# CERTIFICATE OF APPROPRIATENESS PLACARD

# Address BOYLAN HEIGHTS Historic District Historic Property 149-14-MW Certificate Number 9/30/2014 Date of Issue 3/30/2015 Expiration Date

Replace roofing shingles;install attic vents

Raleigh Historic Development Commission – Certificate of Appropriateness (COA) Application

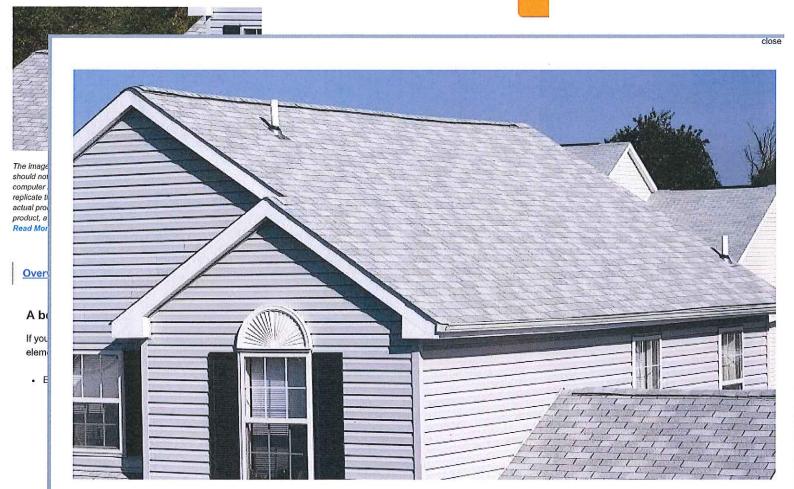
Thanks for the information on the roofing material. Could you provide a photo/rendering and dimensions for the roof vent? Two examples of the kind of information we're looking for are attached.

Thank you for submitting your Certificate of Appropriateness (COA) application for 513 Florence Street . To help us complete our review, please provide the following items and/or clarification:

<ul> <li>Photo or specifications for</li> </ul>	the new roof vent(s)
Γhank you,	
,	
Vivian	
Vivian J. Ekstrom, Planner II	
ong Range Planning Division

Shingles: Certainteed AR "XT 25", color Moire Blk/Sk 3 tap shingles.

• Install electrical exhaust roof vent that vents up to attic (up to 1650sq. ft.) 1170CFM, pre-wired thermostat included, also overload protection and includes electrical wiring connection.
